**COUNTY OF SAN MATEO
PLANNING AND BUILDING DEPARTMENT**

SUBJECT: EXECUTIVE SUMMARY: Consideration of an appeal of the Coastside Design Review Committee's decision to approve a Design Review Permit and Grading Permit pursuant to Section 6565.3 of the County Zoning Regulations and Section 9283 of the County Ordinance Code, for the construction of a new 2,771 sq. ft. two-story single-family residence, with an attached 507 sq. ft. two car garage, 330 cubic yards of grading and no tree removal, on a vacant 5,230 sq. ft. parcel, located between 631 and 647 El Granada Boulevard , in the unincorporated El Granada area of San Mateo County.

County File Number: PLN 2019-00162 (Love/Zheng)

SHEET: **A2.02**
 OF SHEETS

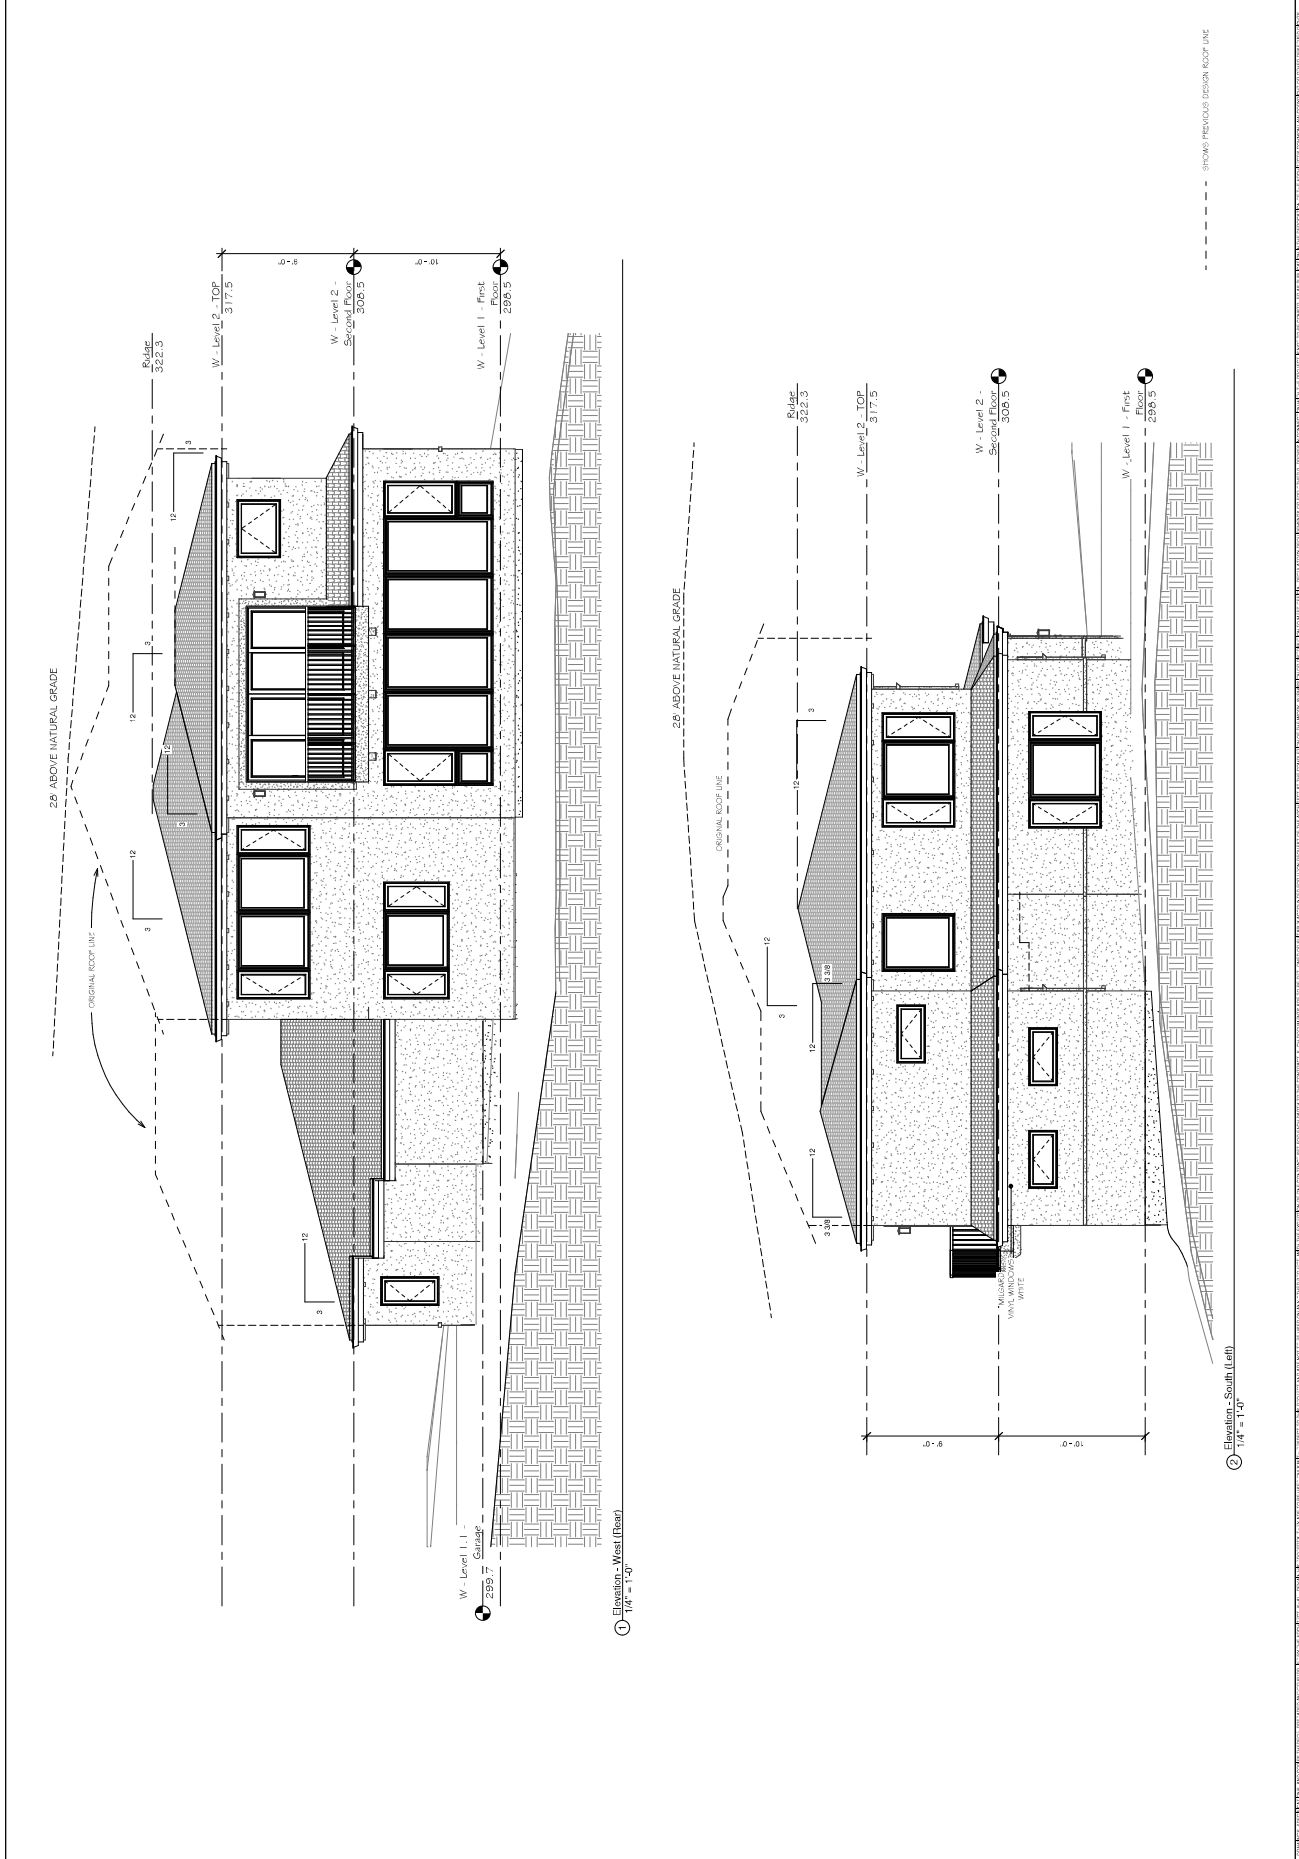
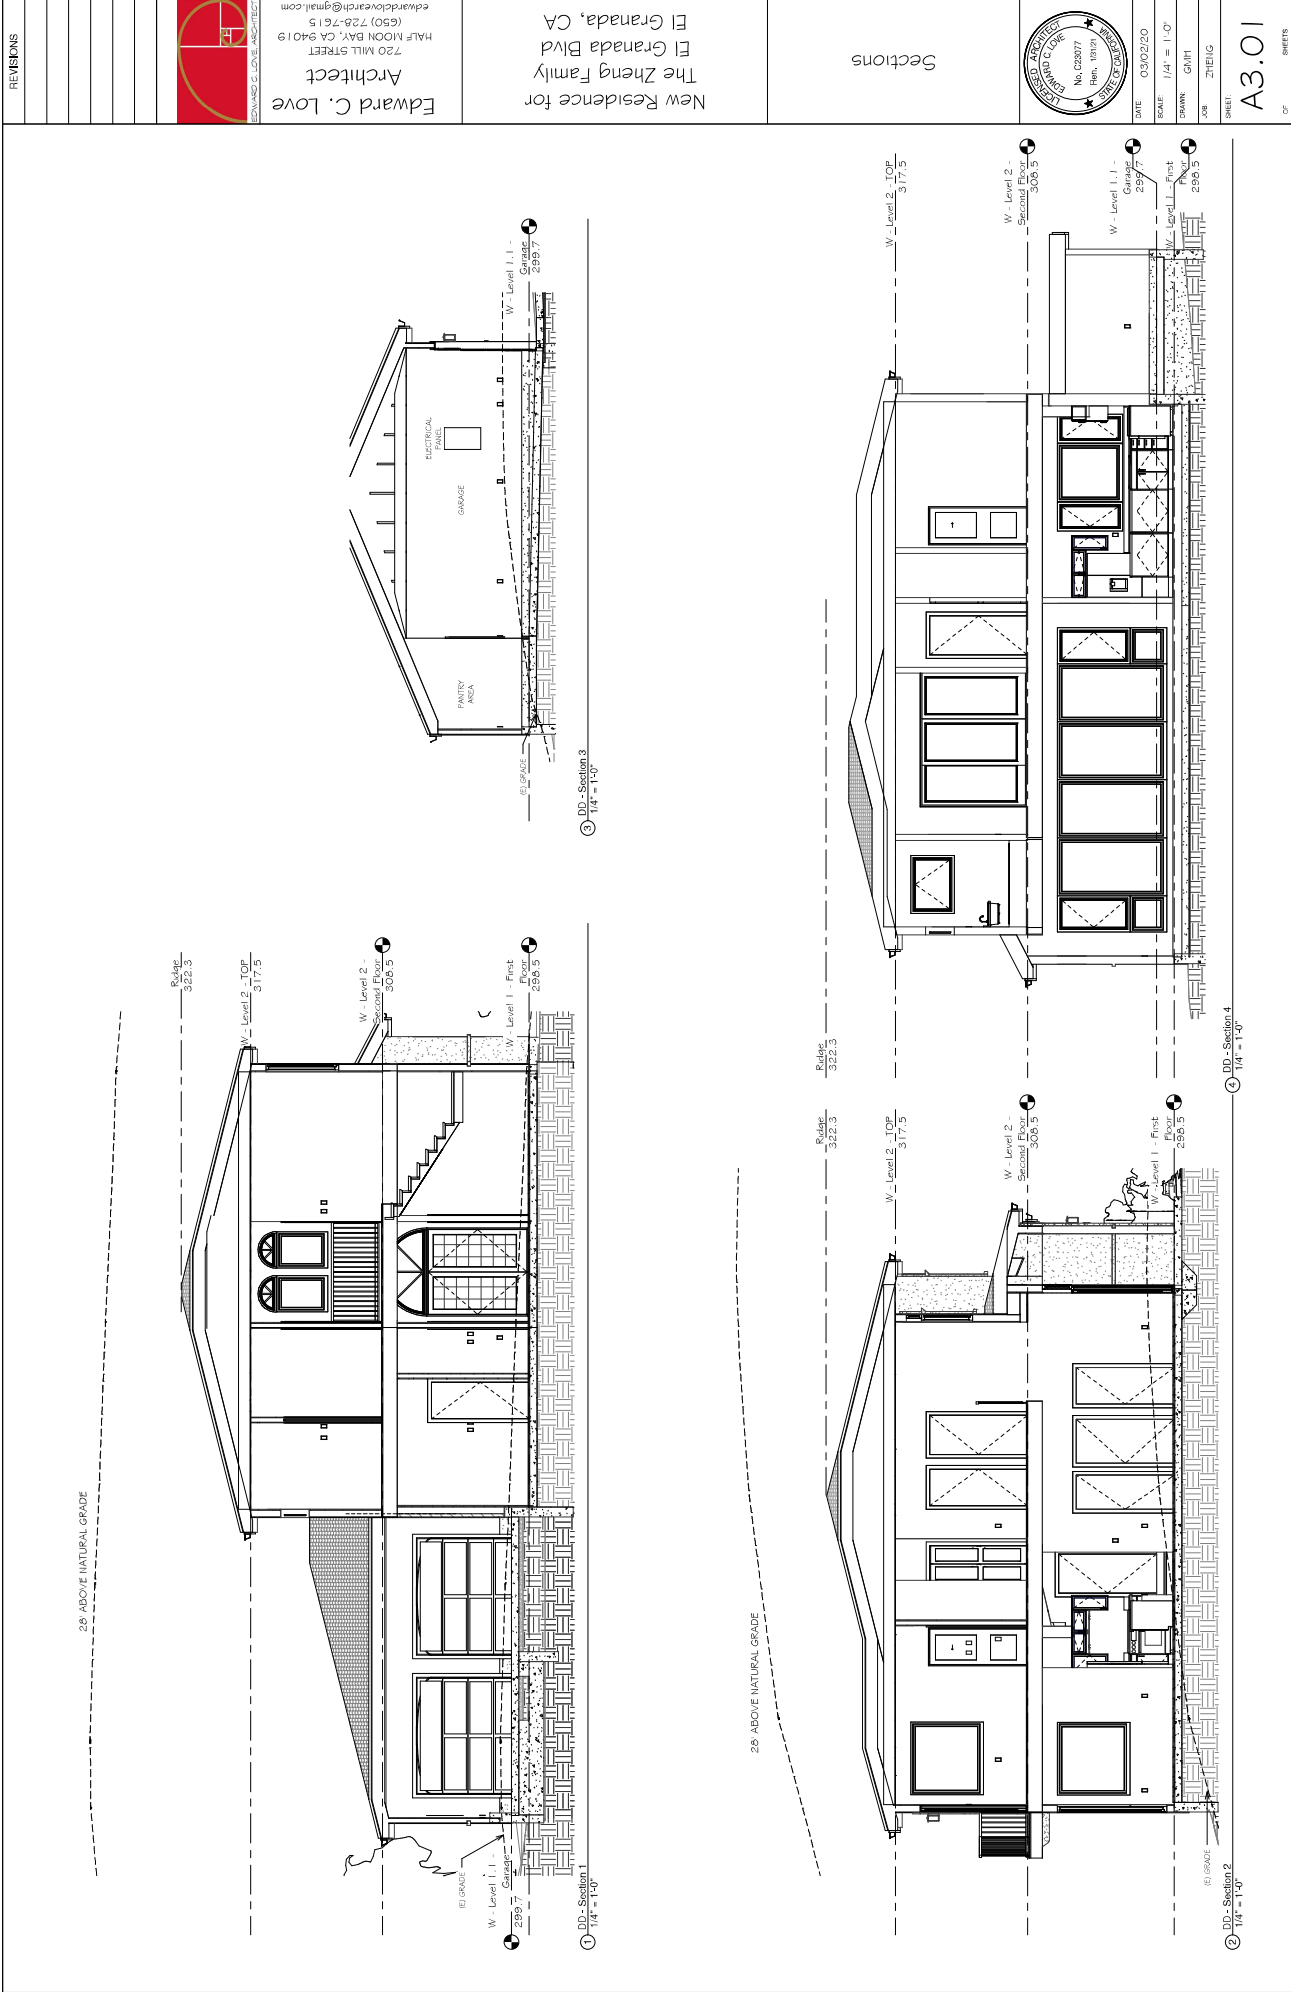
Furthermore, at the February 13 meeting the Committee recommended that Mr. Zheng do the following: “Step down the master suite/living room/kitchen area to visually break up the roofline and follow the natural grade.” As shown on Sheet A2.02, Mr. Zheng did not incorporate this change at all. As a result, Mr. Zheng’s proposed house still appears to be distastefully high, which negatively impacts the views of neighbors who live across/up the street from the proposed house. Stepping down this segment of the house could substantially improve the appearance of the house and it is disappointing that Mr. Zheng ignored this Committee recommendation.

The second story master bedroom wall on the southside of the property still lacks sufficient articulation. Instead, it appears to be mostly a flat wall—which is unsightly from both my living room from which it is prominently visible and also from the street view. I ask that the Committee require an addition of some tasteful, moderate ornamentation to this section of the wall in order to provide sufficient articulation in compliance with the Design Review Standards. The pertinent portion of the wall is yellow highlighted in the following excerpt of Sheet A2.02:

Figure 3 - Steep brush covered slope below proposed house

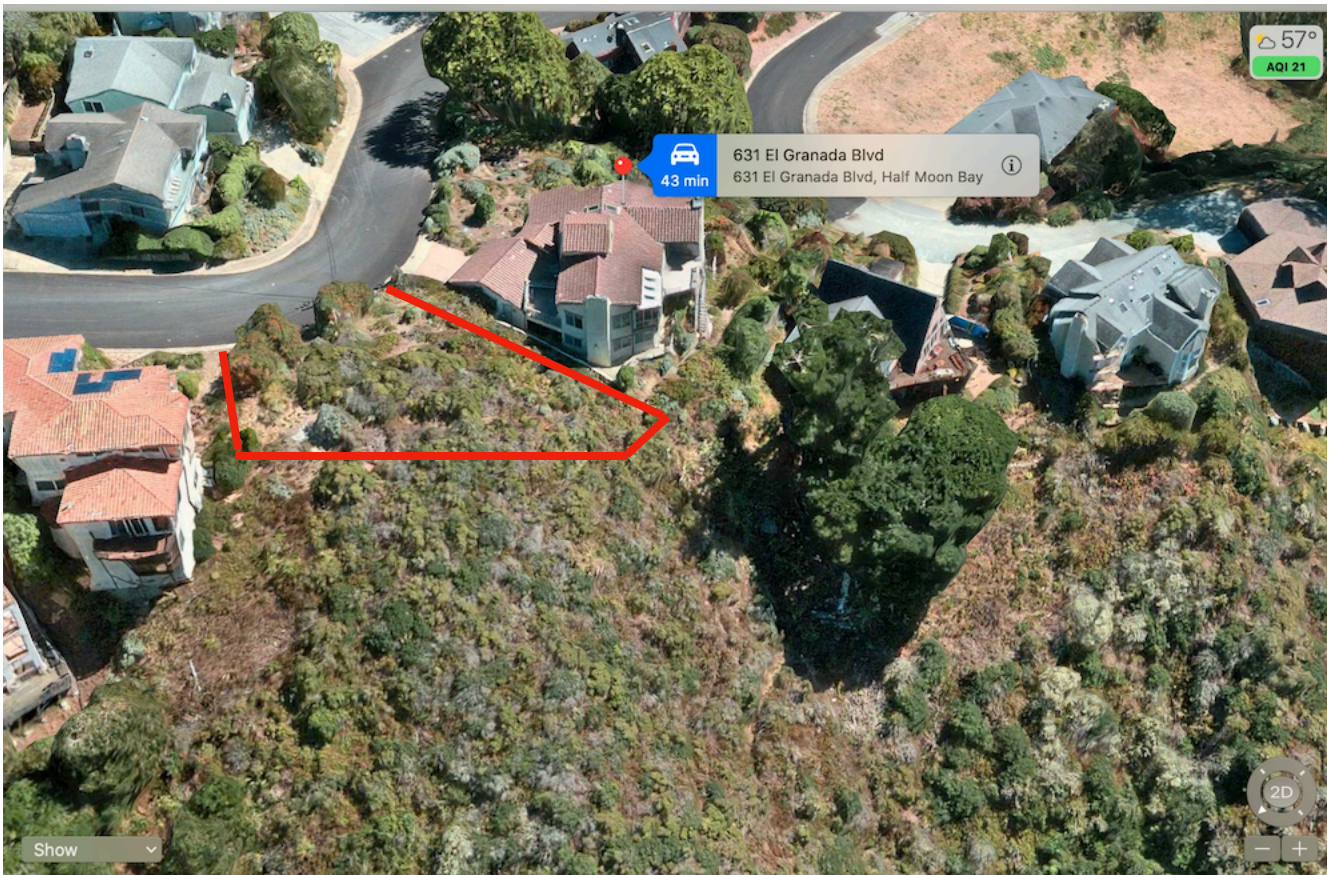
Because the ground slope becomes much steeper on the adjacent parcel [see Figure 3 below], ***the concentrated runoff will increase in speed and turbulence and cause more erosion. The gully will continue to enlarge and eventually extend the erosion onto multiple adjacent and nearby properties with significant loss of land.***

Because the ground slope becomes much steeper on the adjacent parcel [see Figure 3 below], the concentrated runoff will increase in speed and turbulence and cause more erosion. The gully will continue to enlarge and eventually extend the erosion onto multiple adjacent and nearby properties with significant loss of land.

Because the ground slope becomes much steeper on the adjacent parcel [see Figure 3 below], the concentrated runoff will increase in speed and turbulence and cause more erosion. The gully will continue to enlarge and eventually extend the erosion onto multiple adjacent and nearby properties with significant loss of land.
